**PARTS AND PRODUCTS:**

**Old parts**

**New parts**

Figure 1: Old UWE Easy Term 2000 defroster control switch and 7 pin, non-secondary lock connector

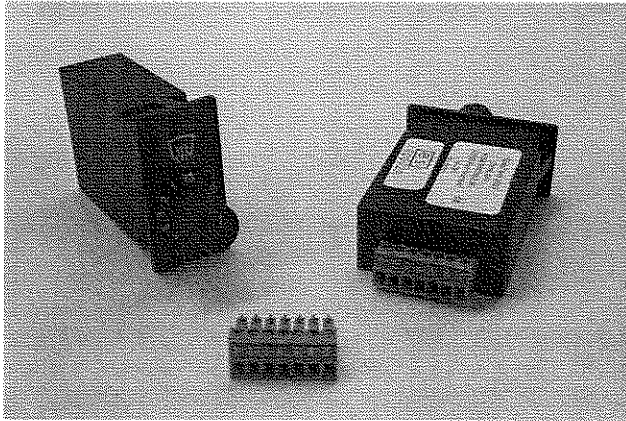
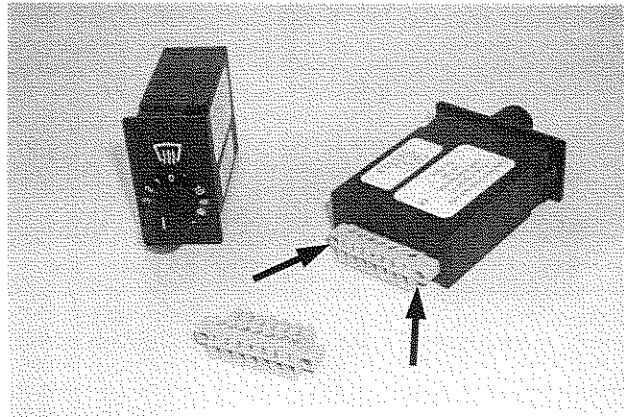
Figure 2: Same as Figure 1, but w/ secondary lock connector. Arrows indicate the captive screws which secure the connector to the housing.

- Old and new parts are interchangeable, but only the new will be offered for service replacement.
- The secondary lock function is available only if the control switch is provided with threaded holes in the back of the housing. Plug retaining screws are captive and are not sold separately.
- Parts may be purchased from your nearest ABC Customer Care & Parts Source dealership.
- Parts and products disposition: discard according to applicable environmental regulations.

- To remove the plug from the control switch, simply undo both connector screws at the back of the housing using a small screwdriver, then withdraw the connector.
- To install, plug-in the connector while taking care not to bend the terminals, then secure finger tight with the screws.
